DRAWINGS

REMARKS

Claims 1-11, 13-16, and 18-28 are pending. Reconsideration and allowance are respectfully requested in light of the following remarks.

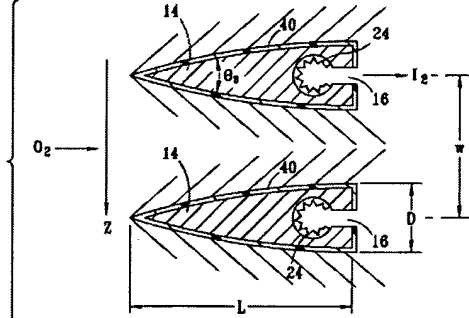
Another Replacement Sheet of Figure 1 has been included, wherein the following text has been added:

“I₂, and optionally an N₂ or He carrier.”

Regarding items 6, 11, and 12, Applicant previously amended Figure 1 to include the missing features. However, Applicant has, again, amended Figure 1 to include these features in case previous amendments to Figure 1 have not been entered. Accordingly, Applicant respectfully requests that the objections to the drawings for items 6, 11, and 12 be withdrawn.

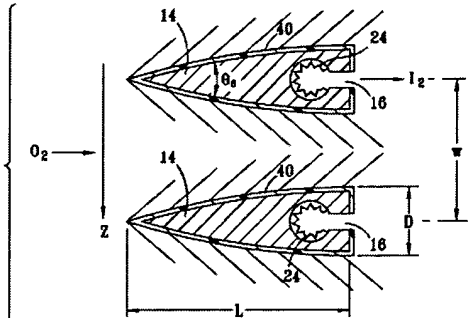
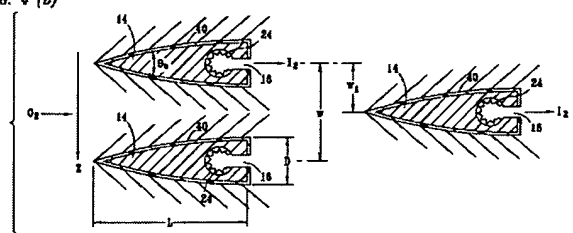
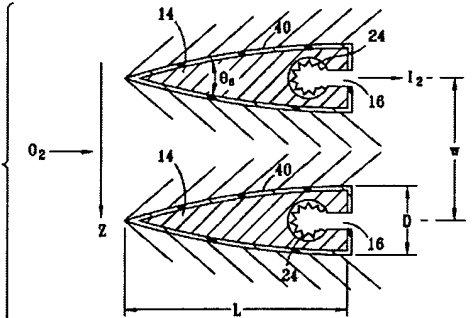
Figures 4 and 5 had been previously withdrawn from reconsideration. However, Applicant seeks to reintroduce Figures 4 and 5. MPEP §809.02(c) reads as follows:

Because Figures 4 and 5 have been reintroduced, items 1-5, 7-10, and 13-15 are depicted in Figs. 4 and 5. Applicant has provided the table below explicitly showing each of these features in the drawings for claims that have not been cancelled.

Item No.	Item	Drawing	Specification
1	sharp wedge with an angle less than 45°	<p>FIG. 4 (a)</p>	<p>“The angle θ_s preferably ranges from 5° to 45°, and most preferably is around 20° or less.”</p> <p>Pg 27, lns. 7-8.</p>
2	sharp wedge with an angle less than 20°		
3	struts has a coating		<p>“The struts have a coating 40 and have</p>

<p>heater elements 24. Coating 40 may be Teflon, nylon, or other plastic material.”</p> <p>Pg. 27, lns 8-10</p>
4	orifice is circular	Claims have been cancelled.	
5	orifice is oval		
7	the diameter of an injected iodine plume is equal to or less than the width of the strut		
8	at least two struts	<p><i>FIG. 4 (a)</i></p> 	<p>“FIGURE 4(a) shows two struts, in cross-sectional top view. The iodine flows through feed duct 20 and exits through orifice 16. The oxygen gas flow direction is shown as well as the optical direction, denoted as z in FIGURE 4(a). The spacing between adjacent struts is w.”</p> <p>Pg. 27, lns. 1-5</p>
9	at least one fin	<p><i>FIG. 5 (a)</i></p> 	<p>“FIGURE 5 shows the possibility of using one or two small fins 26 or of using oblong orifices 16. The purpose of using fins or oblong orifices is to assist in the rapid formation of an iodine layer near the base of each strut if</p>

necessary or desired.” Pg. 27, lns 10-13
10	sharp ogive	Claim has been cancelled	
13	two struts	<p><i>FIG. 4 (a)</i></p> 	<p>“FIGURE 4(a) shows two struts, in cross-sectional top view. The iodine flows through feed duct 20 and exits through orifice 16. The oxygen gas flow direction is shown as well as the optical direction, denoted as z in FIGURE 4(a). The spacing between adjacent struts is w.”</p> <p>Pg. 27, lns. 1-5</p>
14	two struts are staggered	<p><i>FIG. 4 (b)</i></p> 	<p>“FIGURES 4(b) and 4(c) show cross sectional top views of alternate embodiments where the struts 14 are staggered.”</p> <p>Pg. 36, lns. 1-2</p>
15	heating element	<p><i>FIG. 4 (a)</i></p> 	<p>“The struts have a coating 40 and have heater elements 24.”</p> <p>Pg. 35, lns. 20-21</p>

Therefore, Applicant respectfully requests that the objections to the drawings for items 1-5, 7-10, and 13-15 be withdrawn.
